**BusConnects Galway  
Cross City Link  
(University Road to  
Dublin Road)**

February 2023

**Galway City Council  
Observations on the  
Proposed Scheme  
Submissions and  
CPO Objections**

| Name        | BCG-GA-00-02             |

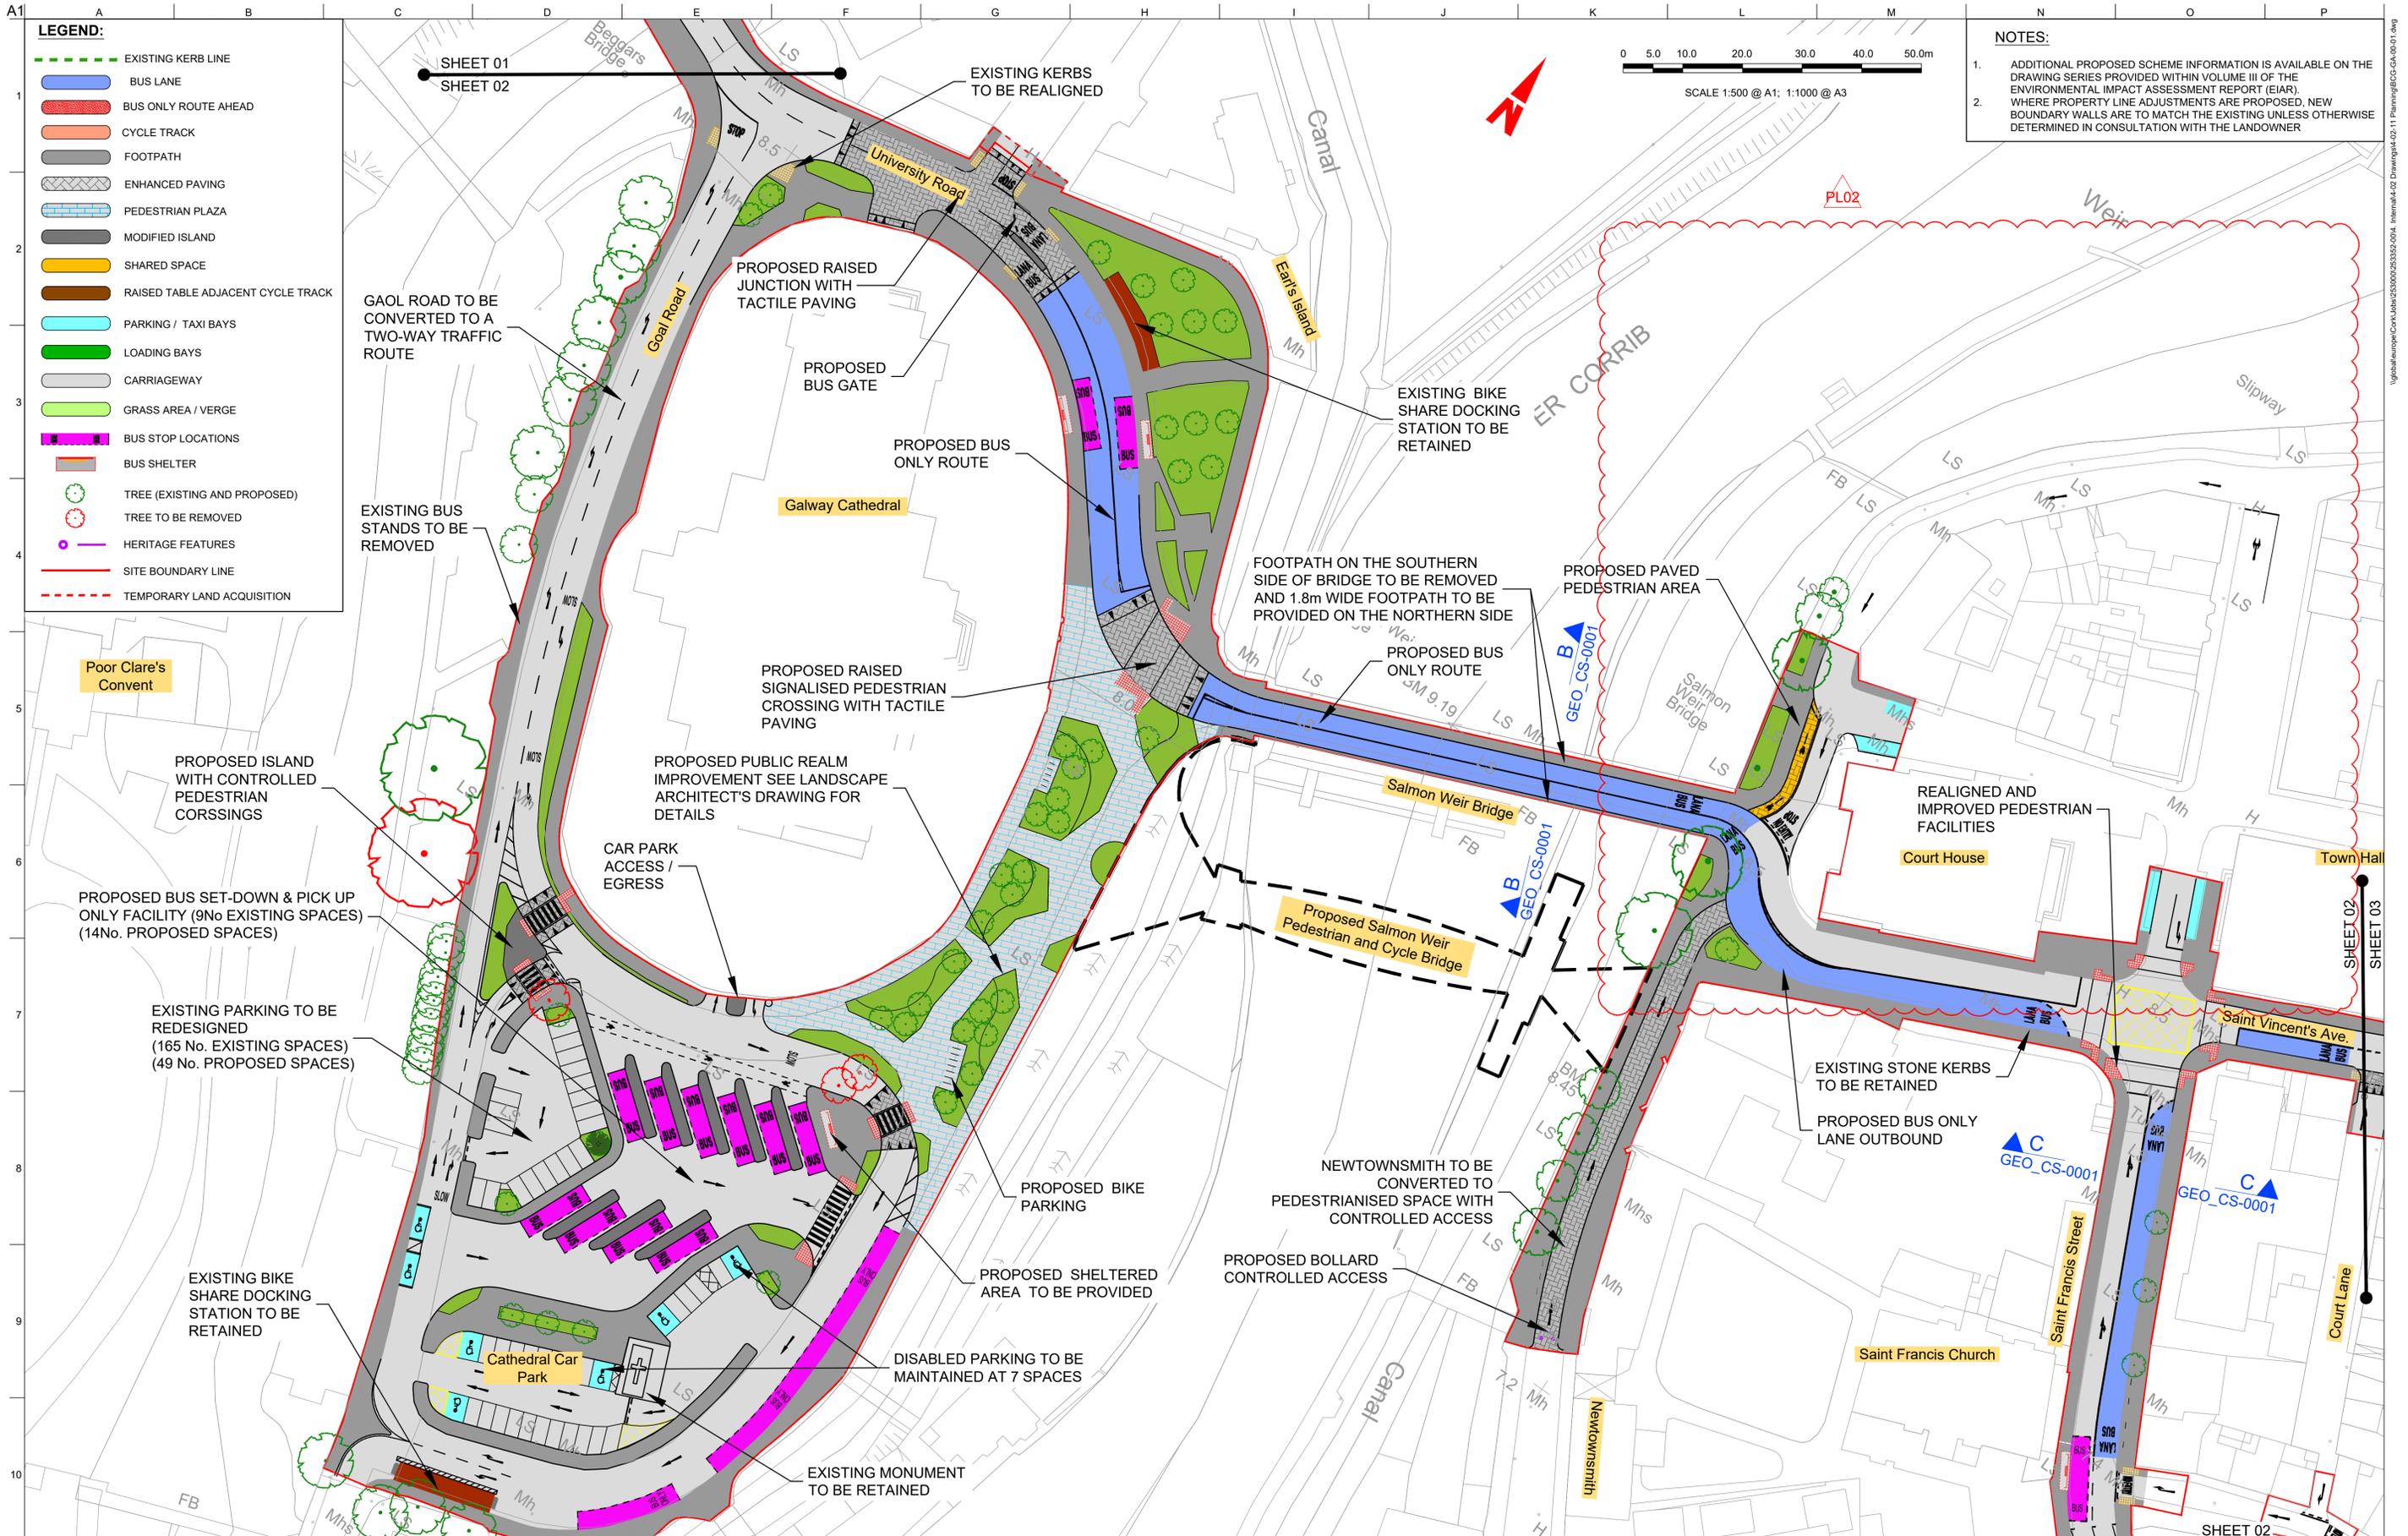
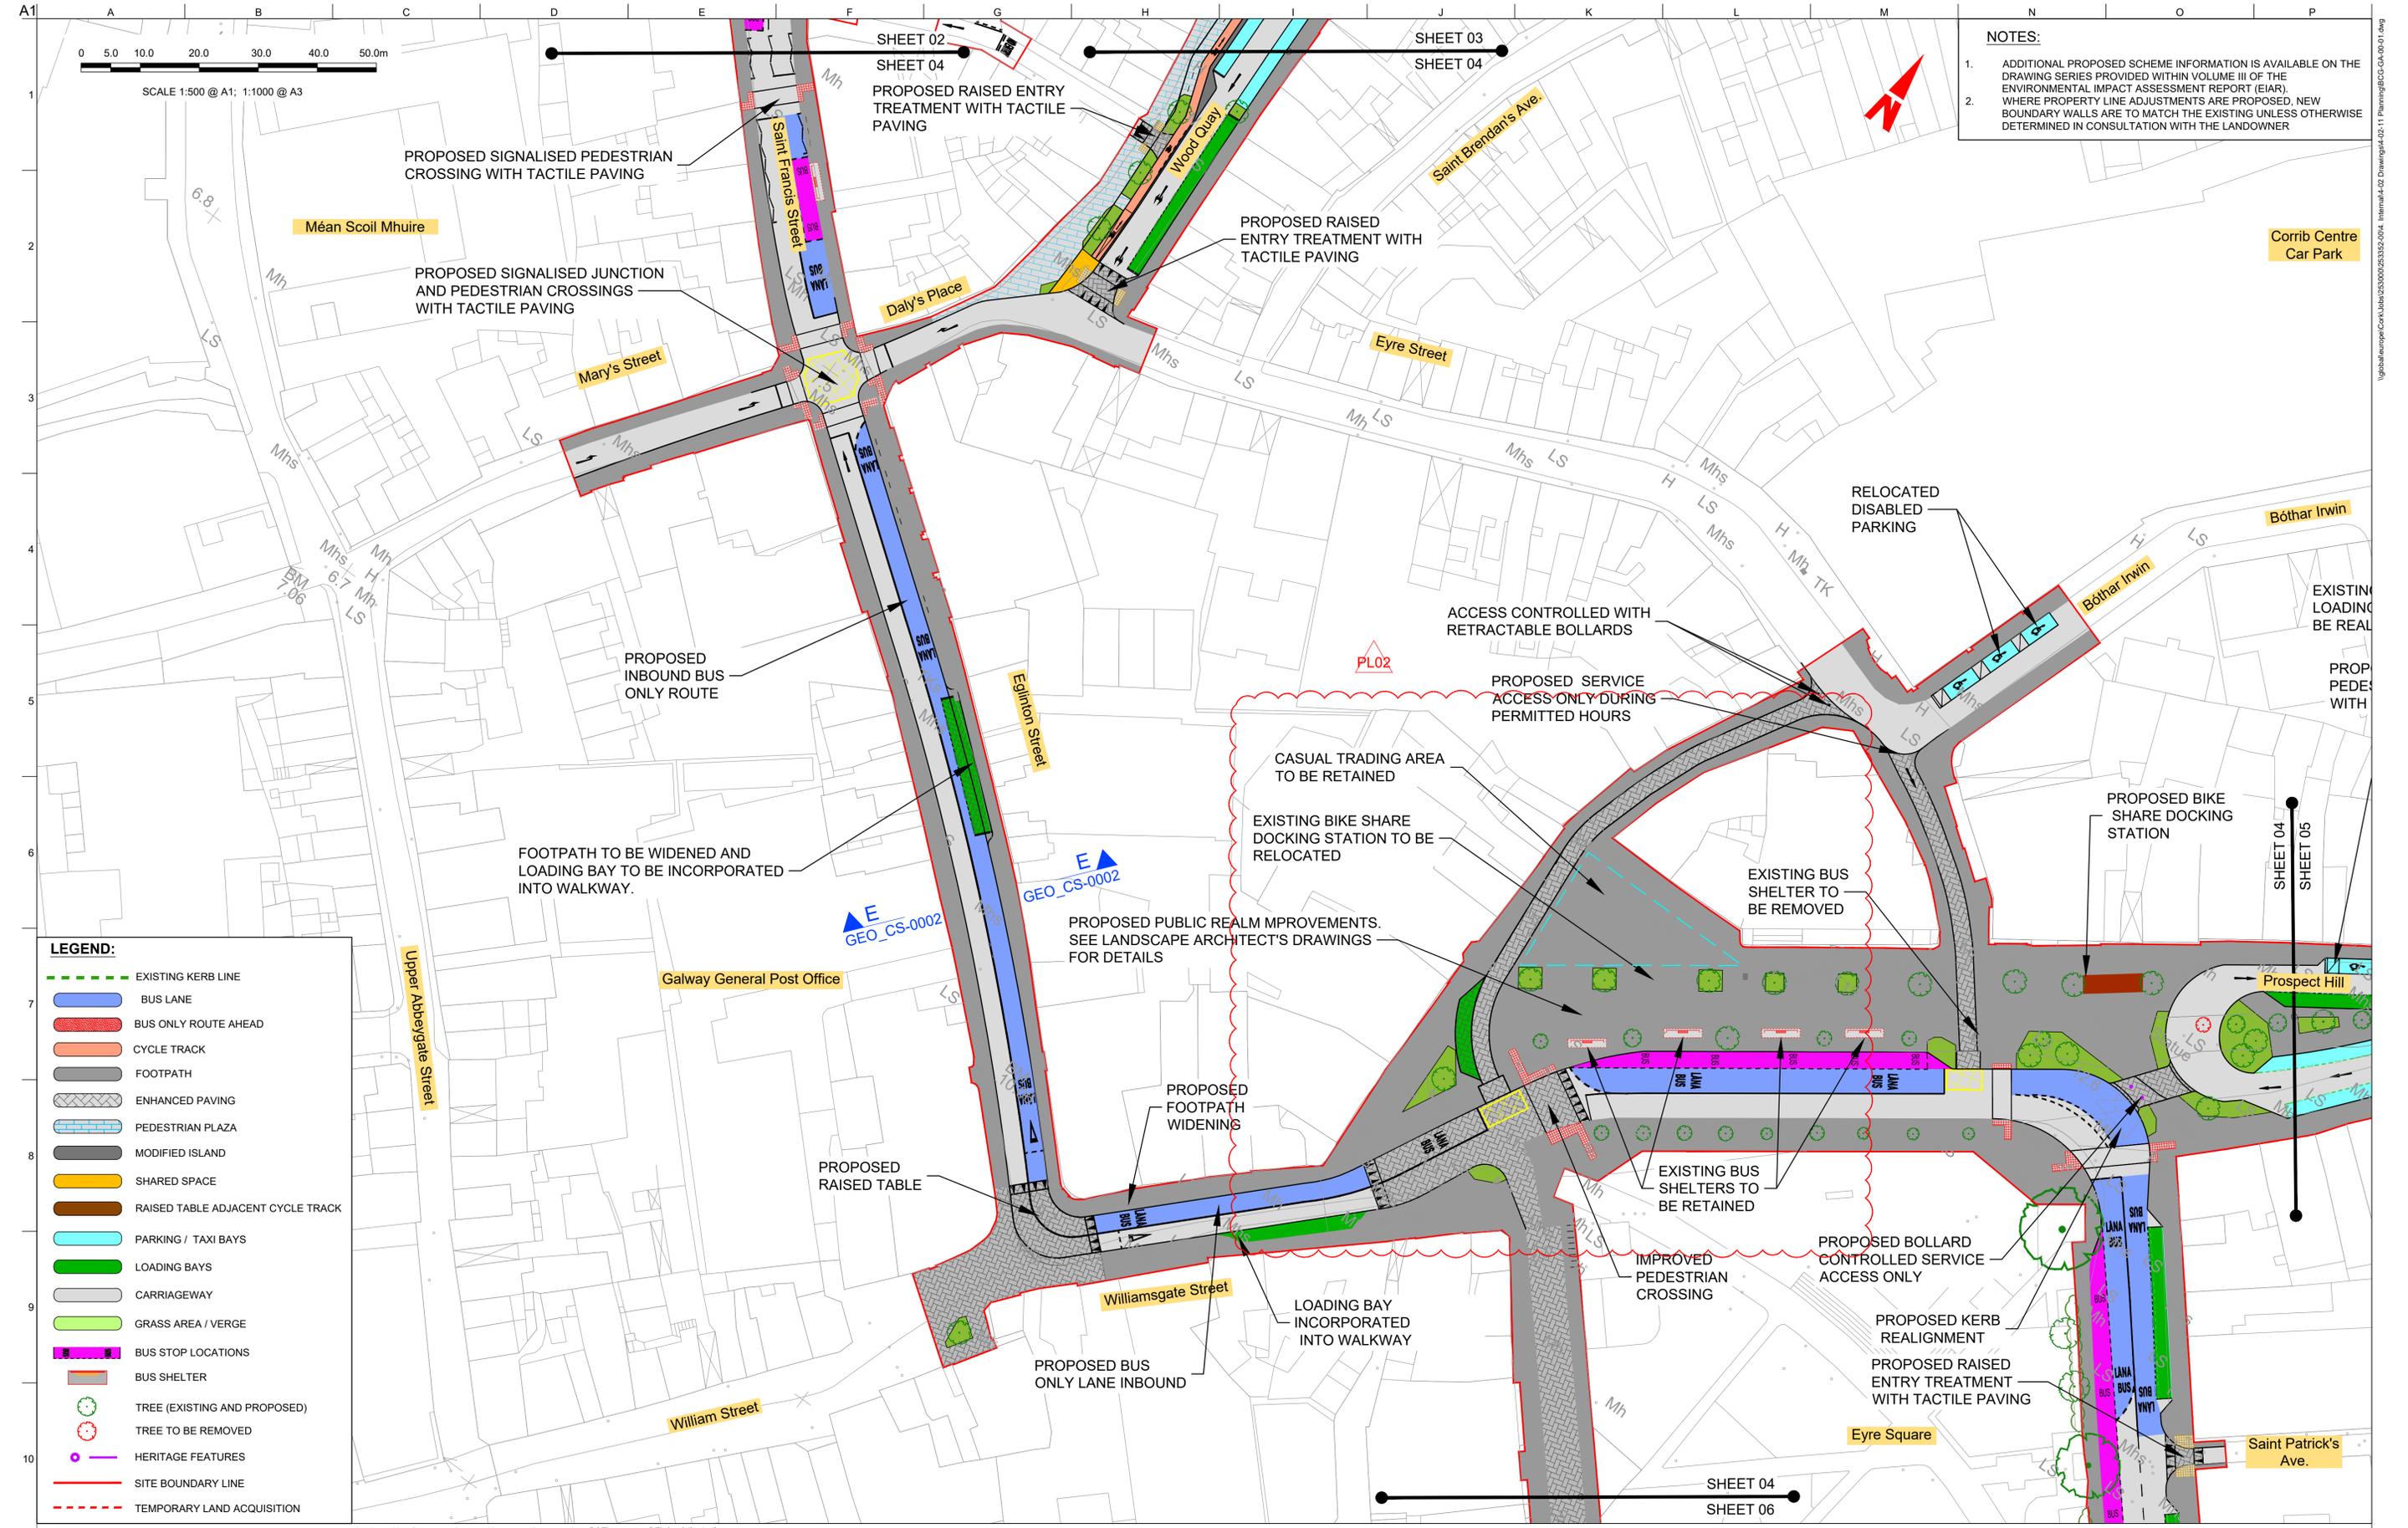
The proposed scheme shall be amended in the vicinity of Galway Courthouse, as per drawing BCG-GA-00-02-PL02.

Drawing Title  
**General Arrangement**

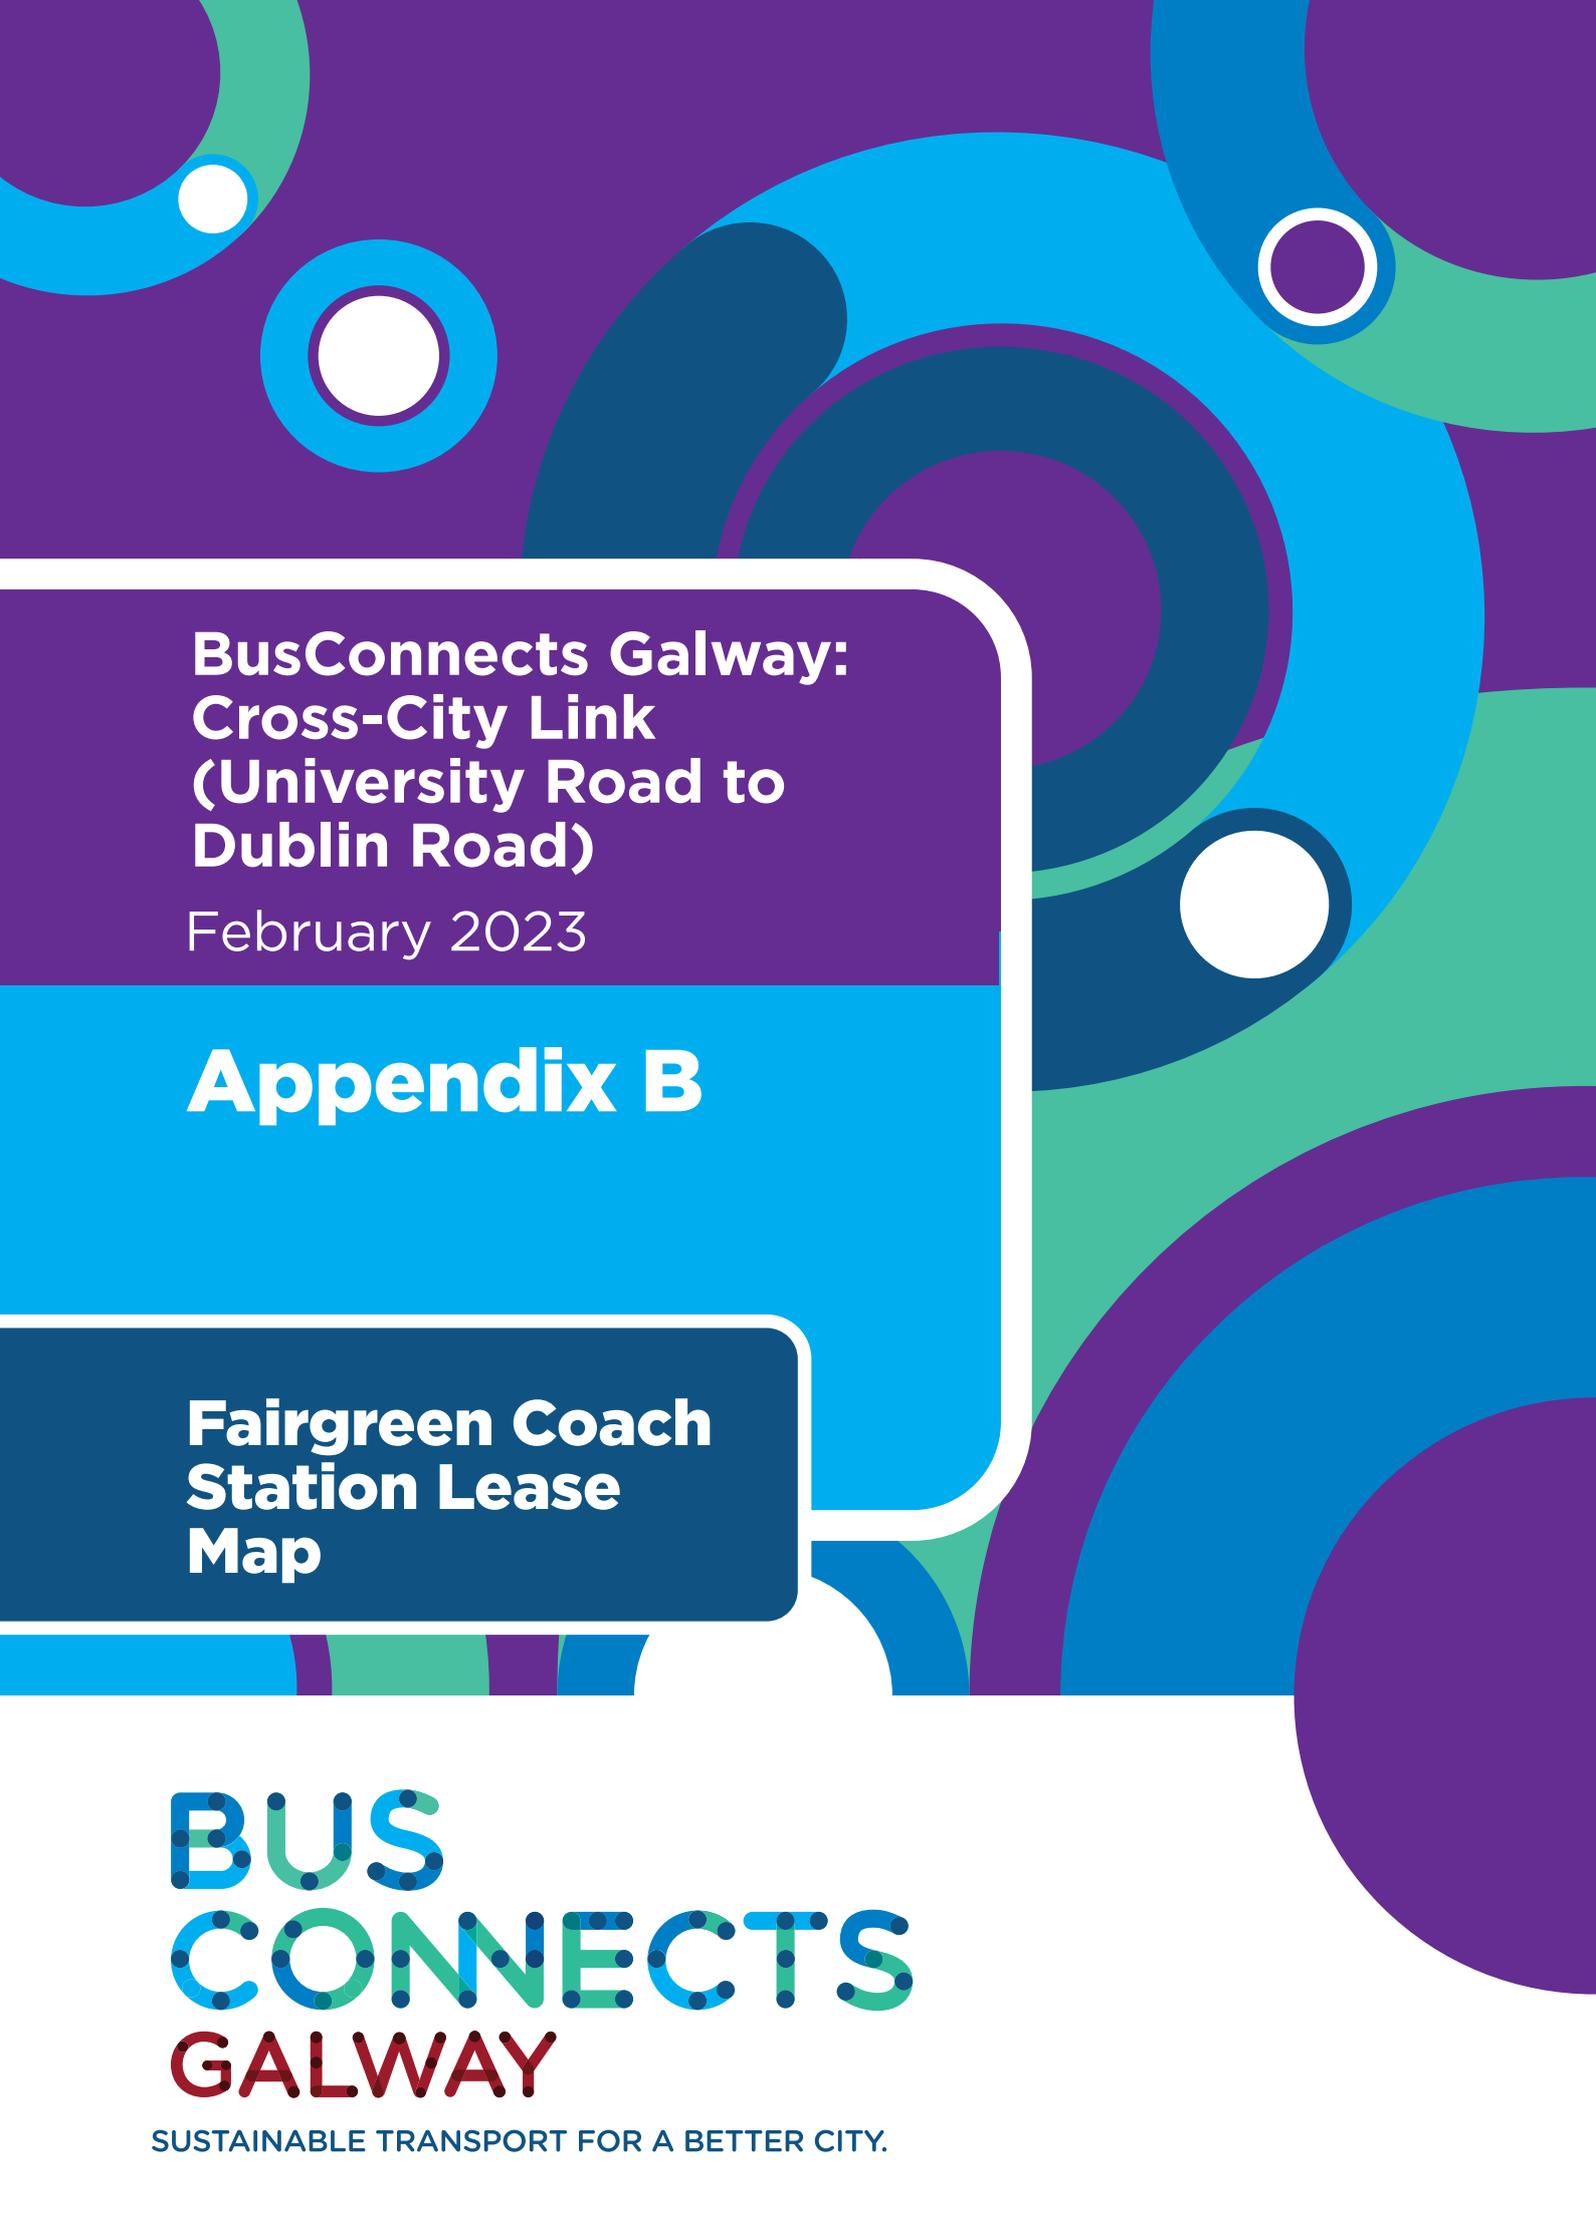
Upon consideration of the concerns of the Devaney Family and other submissions received relating to the Proposed Scheme, Galway City Council will not object to amending the proposed scheme requiring the casual trading area to remain in its current location, should An Bord Pleanála consider this appropriate. Galway City Council suggest that this potential amendment to the proposed scheme can be dealt with by way of a condition of planning, stating that the proposed scheme shall be amended in the vicinity of Eyre Square North, as per drawing BCG-GA-00-04-PL02.
